Historic Preservation Board

November 11, 2015 at 9:00 a.m.

Staff Report
November 11, 2015

COR 15-007 Request by John M. Brennan, Jr. For a Certificate of Review to demolish the existing single car garage and add a freestanding two car garage with a second floor accessory dwelling unit at the rear of his property located at 814 Antonette Avenue. A variance is requested for a ten foot rear setback. Contributing historic resource listed in the College Quarter Historic District. Zoned R-1AA. Parcel ID #07-22-30-1490-01-100.

ALTERNATE/SITE PLAN
1"=20'

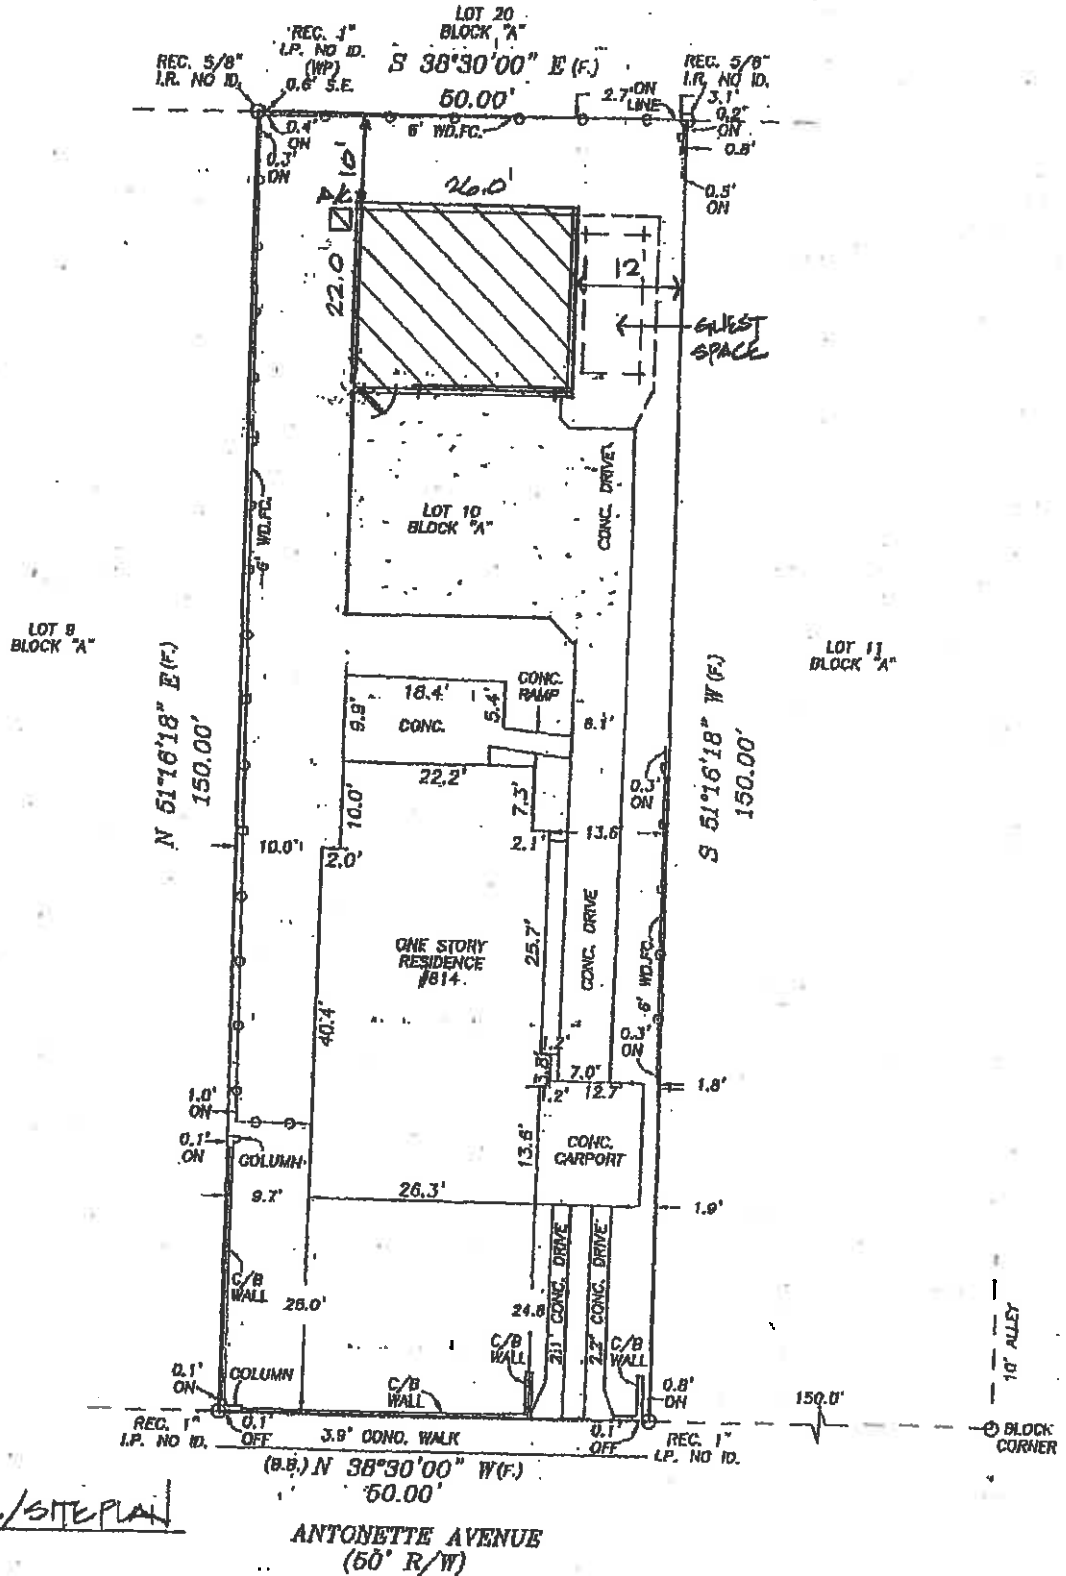
To repeat, all new or reactivated accessory dwelling units require a third separately accessible parking space behind the front setback. The two required parking spaces for the main house are within the new garage and the third space is adjacent to the structure in the 12 foot side setback. When an accessory dwelling unit is added or reactivated, the guest or tenant is required to park on site in a separately accessible parking space. On street parking is very limited in the city's historic areas and the applicant is aware that the use of an accessory dwelling unit is contingent upon the guest or tenant parking on site as required.

Staff has met with the neighbor to the south at 818 Antonette Avenue. Ms. Bosserman had concerns about the two story structure previously proposed five feet from the side of her property. The revised application moves the new structure 12 feet from the side setback. Mr. Miller, the owner of 767 French Avenue adjacent to the rear of the property, had concerns about the five foot rear setback previously proposed. The revised application requests a ten foot rear setback. Rear and side elevations have revised to reduce the size of windows and to raise them order to address privacy concerns.

1. Demolition of the existing single car garage;
2. construction of a two car garage with a second floor accessory dwelling unit; and
3. a variance to allow a ten foot rear setback to the new two story structure.

SCHEMATIC FRONT ELEVATION

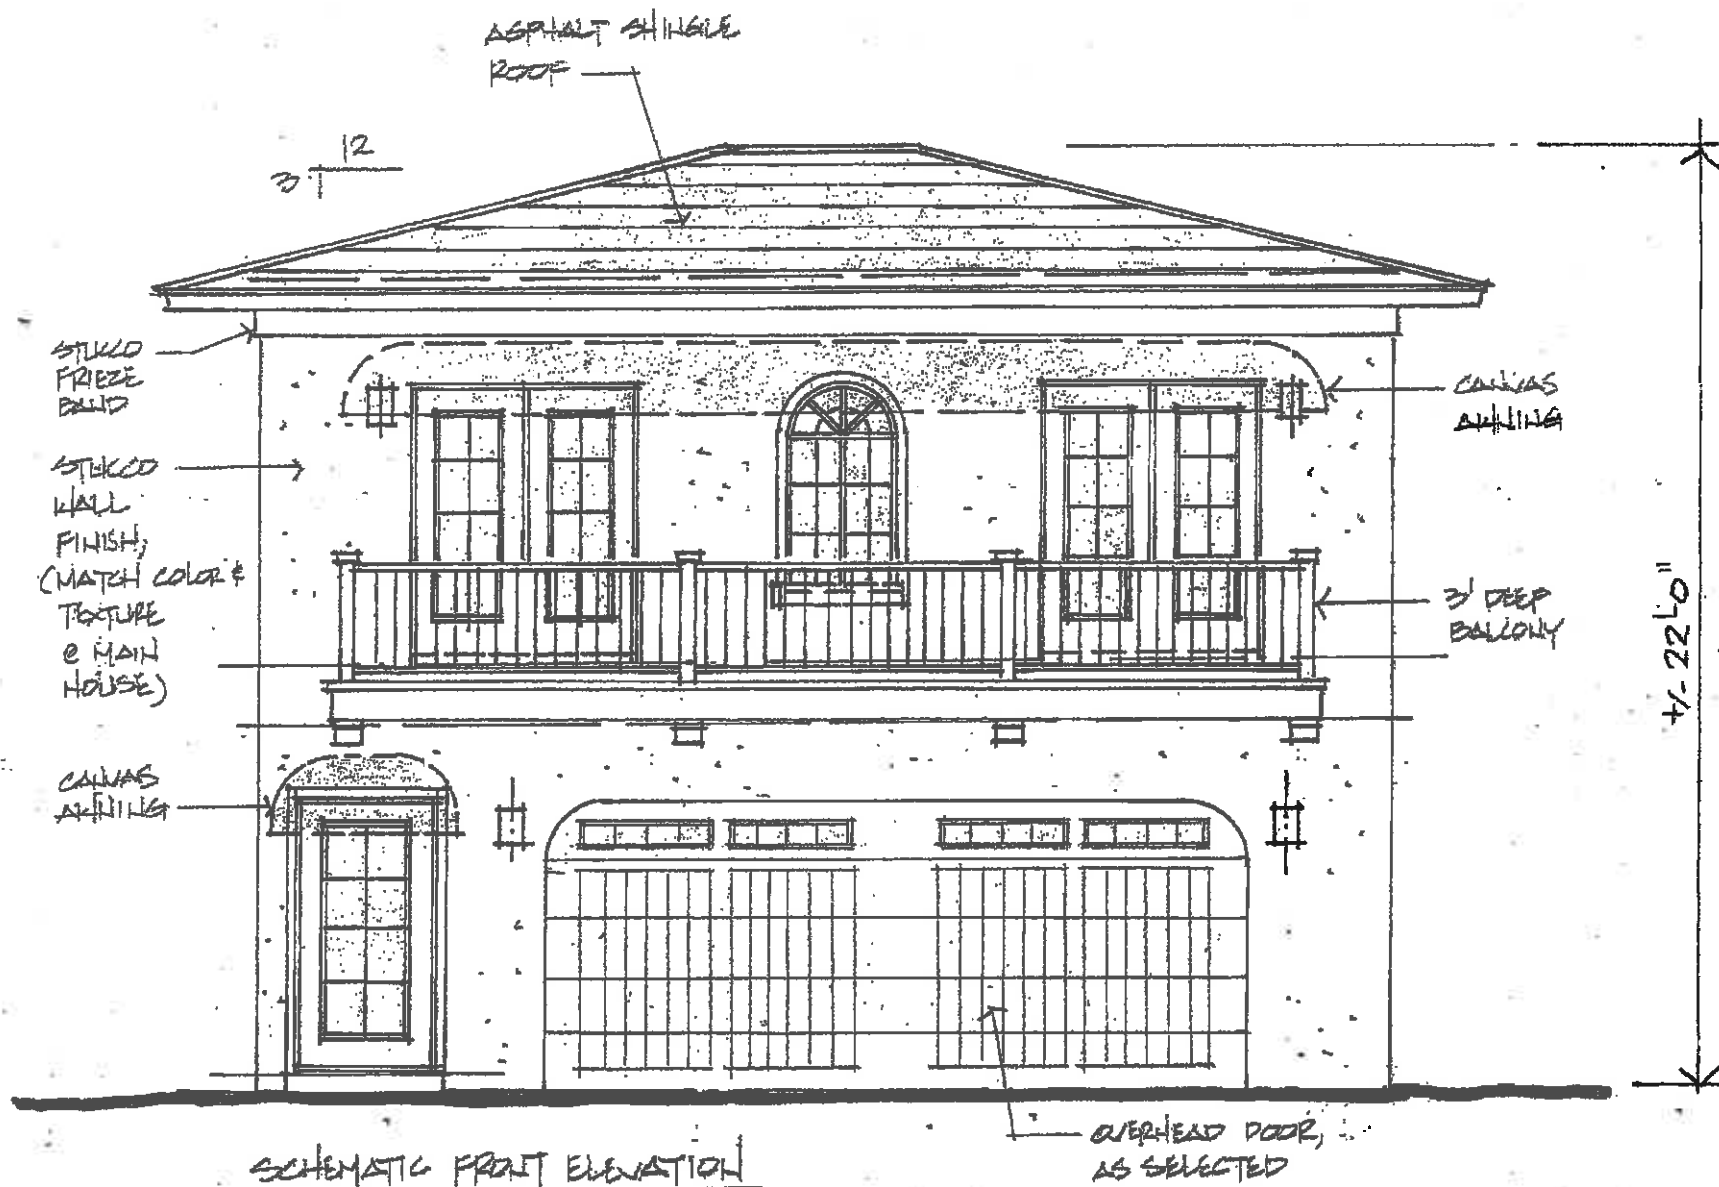
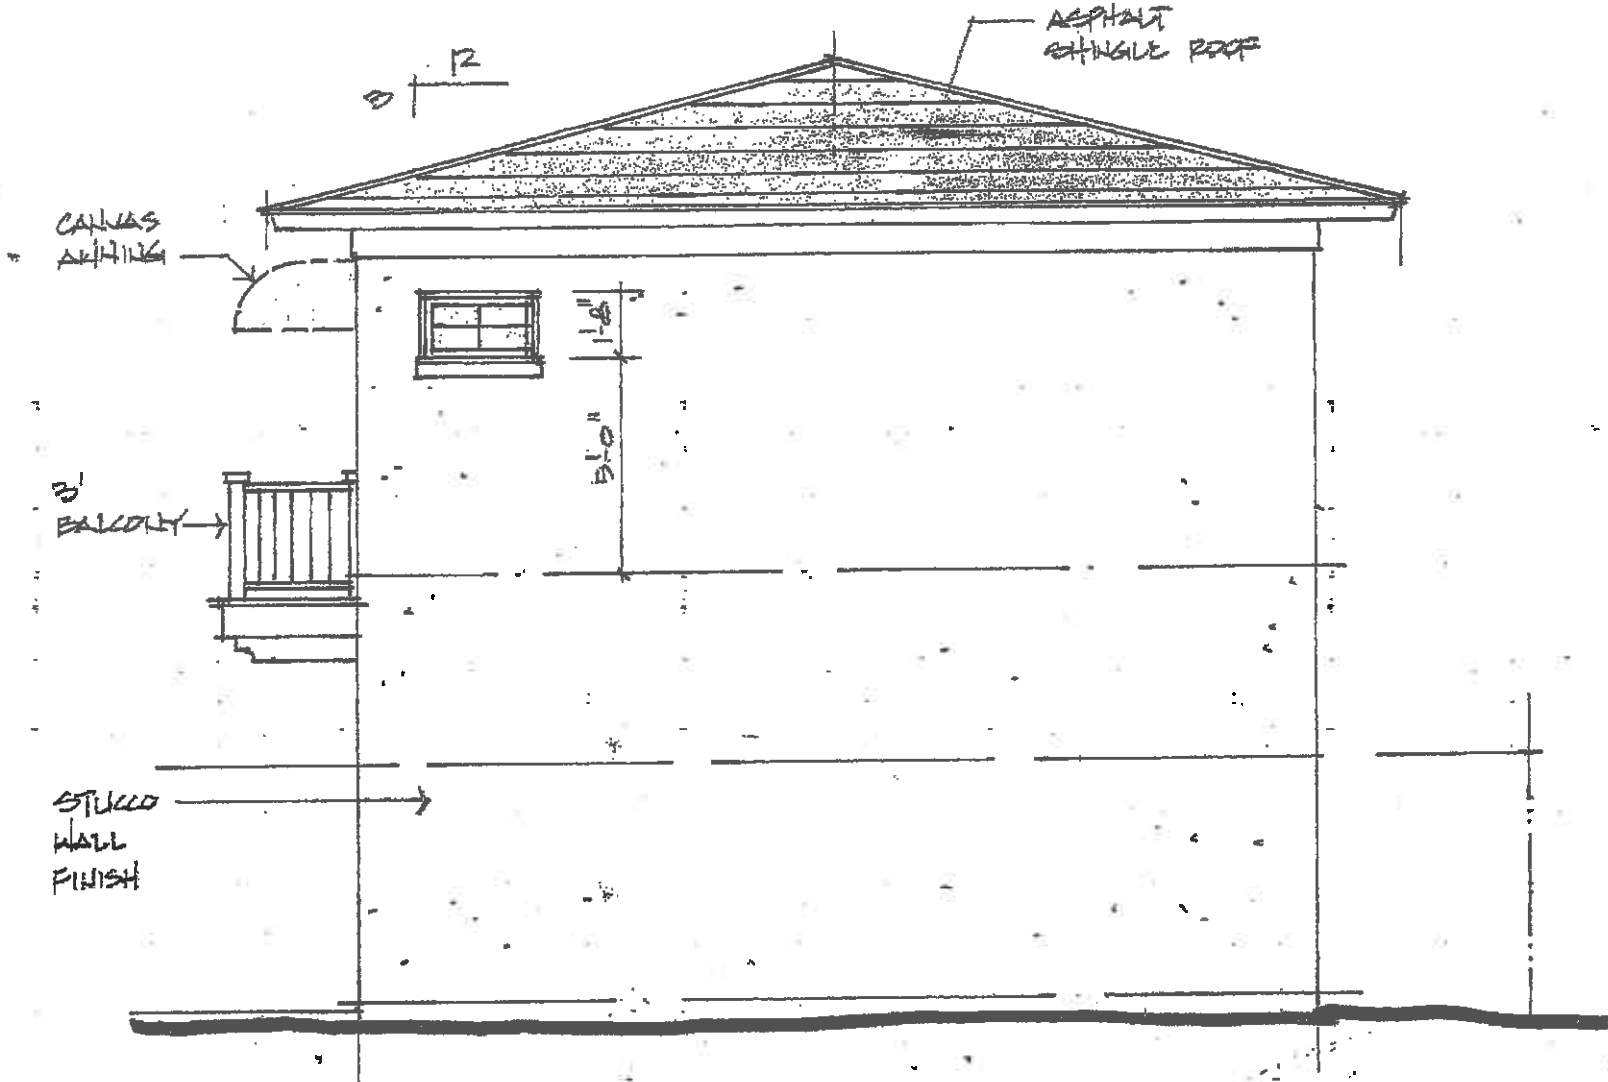
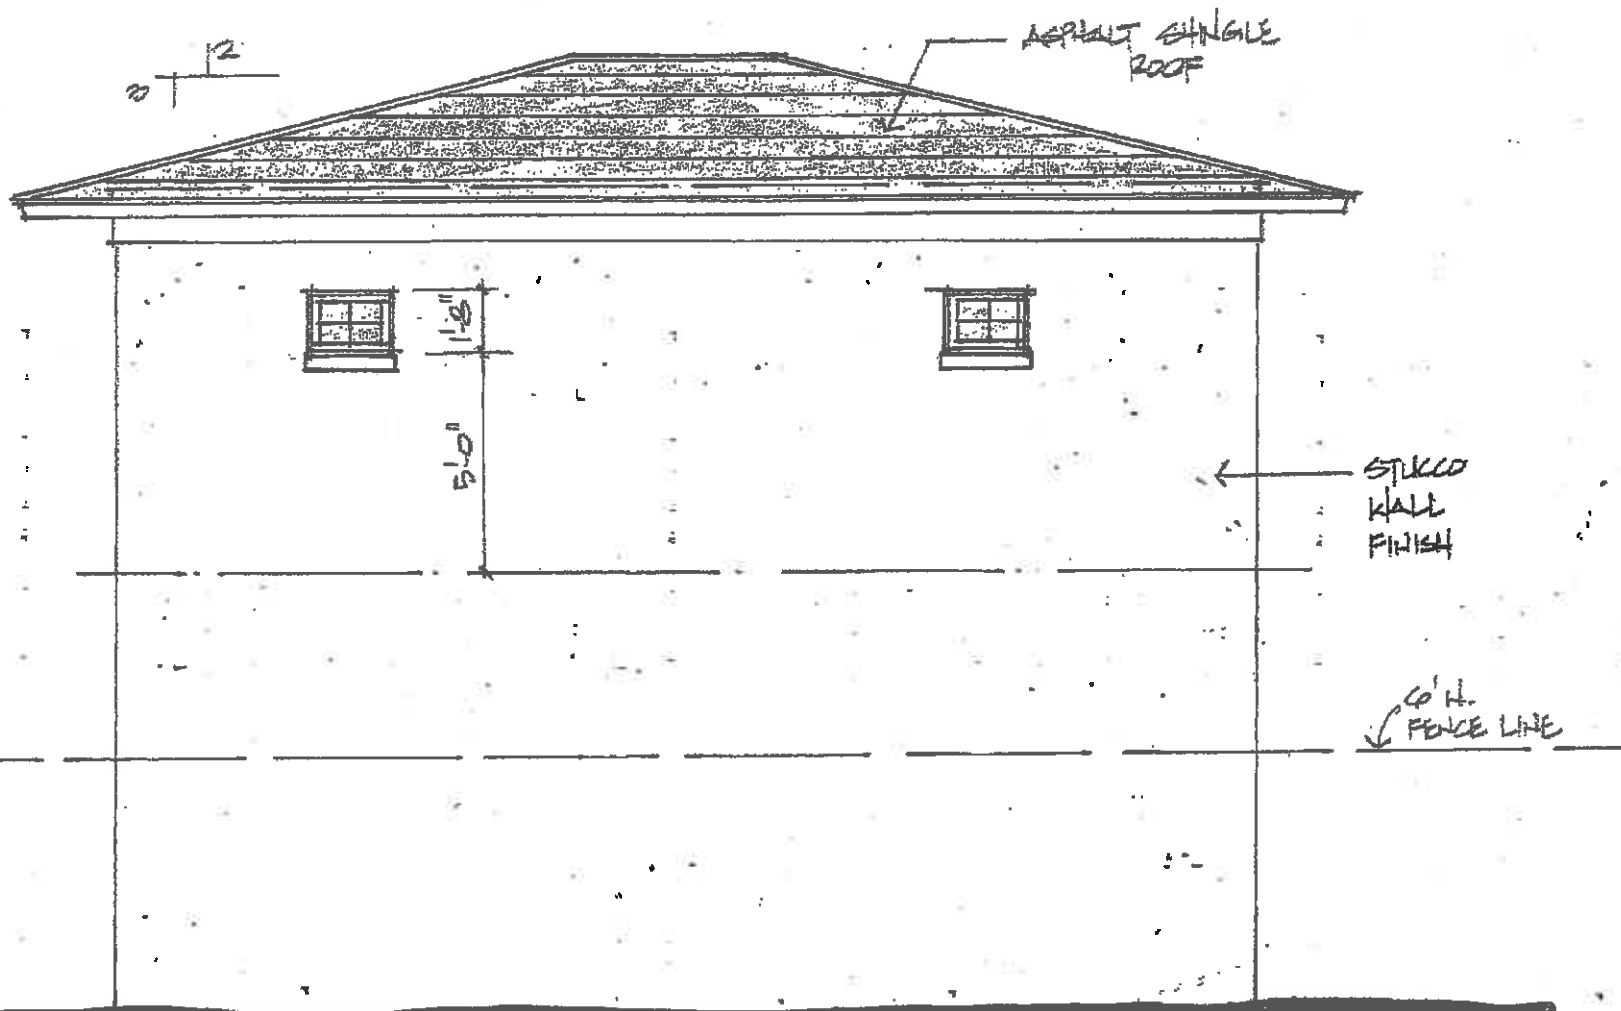
The proposed two car garage with second floor dwelling unit has a 22 foot by 26 foot footprint. The foundation is slab on grade. Exterior cladding is stucco. The asphalt shingled roof is hipped with a moderate pitch which reduces the visual bulk on all sides. The stairs to the second floor are within the structure. Two pairs of French doors and a window access front facing second floor balcony. The required third parking space is provided. The design is compatible with the historic main house without competing with the historic architecture.

The single car garage to be demolished does not add to the historic character of the property. The new construction is freestanding and does not impact the historic house. There are other examples of two story accessory buildings behind one story main houses in the immediate area, so that size and scale of development is not unusual or detrimental. The architecture of accessory buildings does not have to mimic historic architecture, but needs to be compatible as is the proposed structure. Typically, accessory buildings are simpler than the main building.

PROPOSED WEST ELEVATION

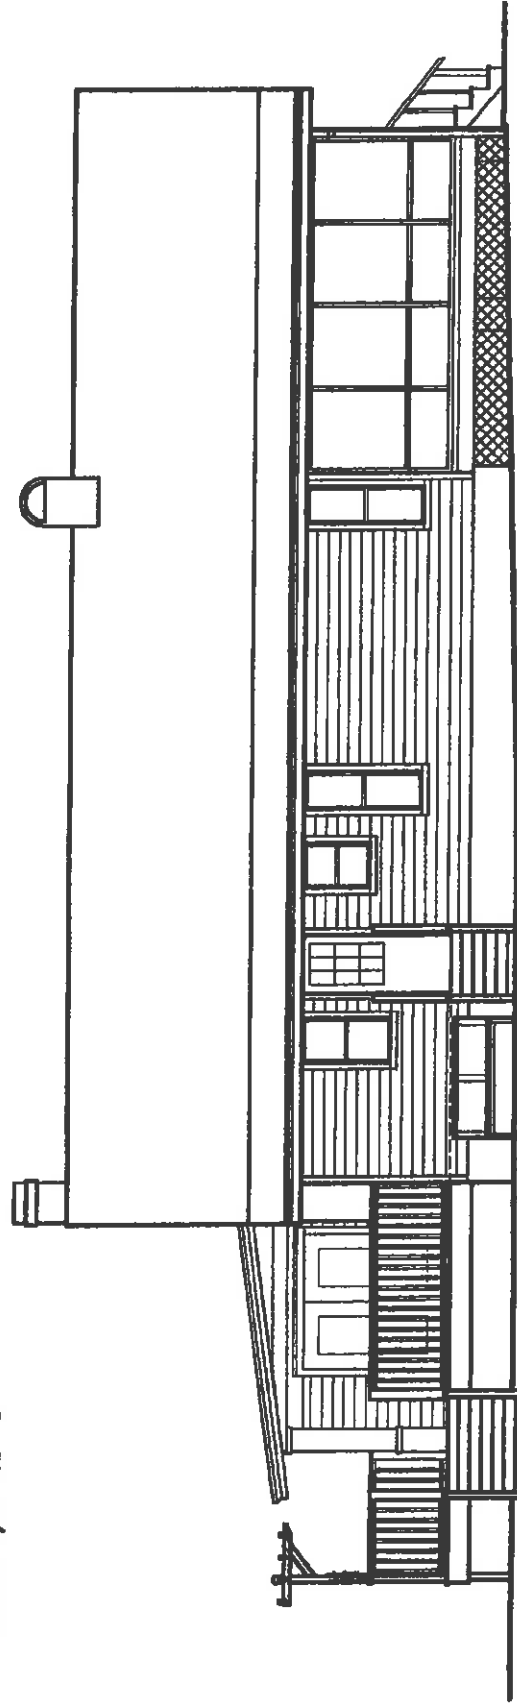
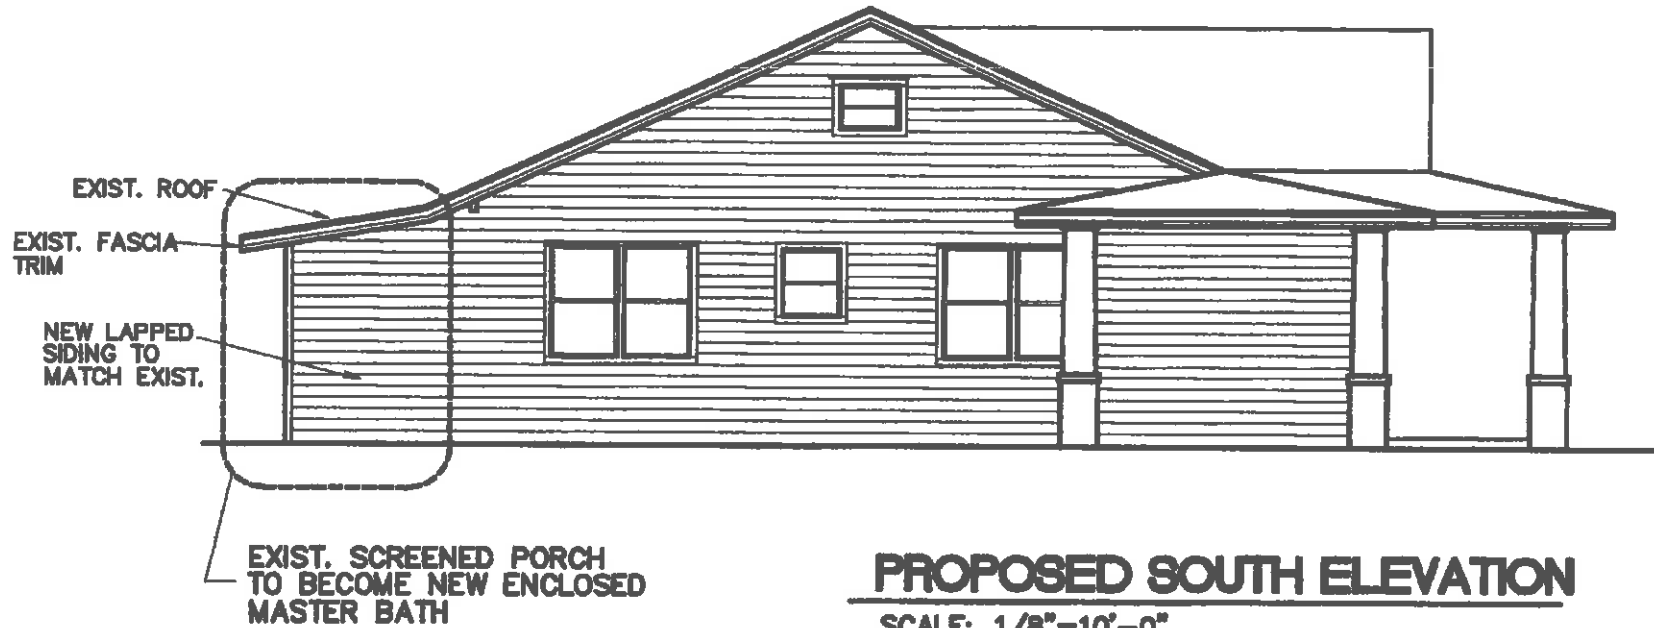
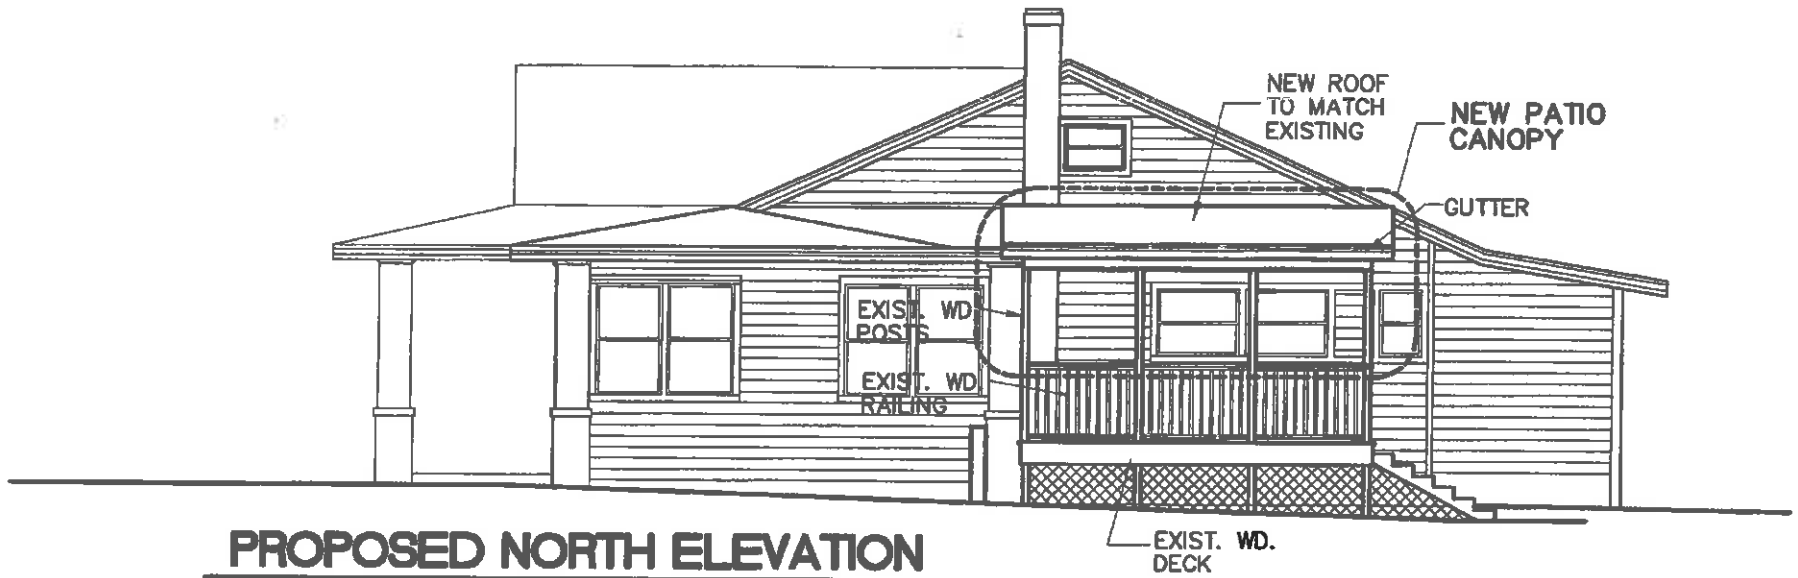
The historic façade of the original house is already covered with newer construction. The enclosure of the rear screened porch has no impact to the district, and the replacement windows and doors, and shade structure are compatible with the historic district environment.

- 1. Enclose existing screened porch on the rear of the home to create space for a master bath. The existing porch is approximately 9 x 15. Exterior finishes for the enclosed porch will match existing exterior finishes. There will be no changes to the existing foot print or roof line of the home.**

- 3. The home is on the west side of Highland Road facing east. Existing windows on the sides of the home which face east and north will be replaced. Plans showing the appearance of the proposed windows accompanies this application. The vendor may be different than the vendor which prepared the plans. However, the appearance will be the same as depicted on the plans.**

RECOMMENDATION: Staff recommends approval of the certificate of review are proposed.
